Follow Up Changes:

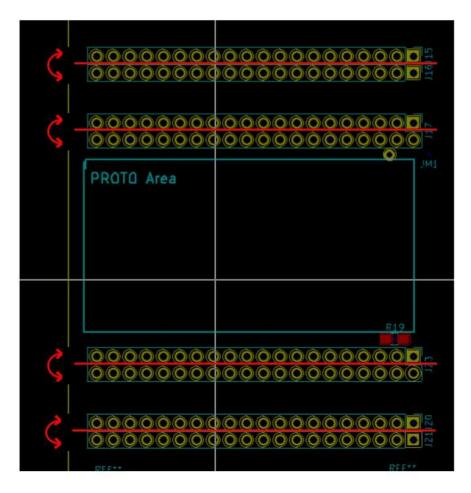
3) trace from F6, Pin 2 to J1, Pin 2 should should increase in width. The trace width to match the 5V coming to the fuse.

Trace from J1 pin 4 through F7 to C4-VCC-3V3 should increase trace width. Trace width should match the C4-VCC-3V3 net trace width.

- 4) Corners of the PCB should be rounded
- 5) JP1-9 pads should be wired together. The are currently still not wired.
- 6) Add proto-area where indicated on the PCB. Proto- area should look like this:

This diagram is for action item 1 and 2. Pins should be flipped along the red axis lines.

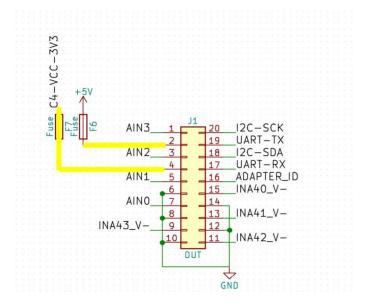
1) J17 needs to be flipped along its horizontal axis. For example, the pad for pin 1 should be where the pad for pin 2 is, and the pad for pin 2 should be where the pad for pin 1 is.

This means that J15 and J16 should switch places, and then be rewired.

2) J23 needs to be flipped along its horizontal axis. For example, the pad for pin 1 should be where the pad for pin 2 is, and the pad for pin 2 should be where the pad for pin 1 is.

This means that J20 and J21 should switch places, and then be rewired.
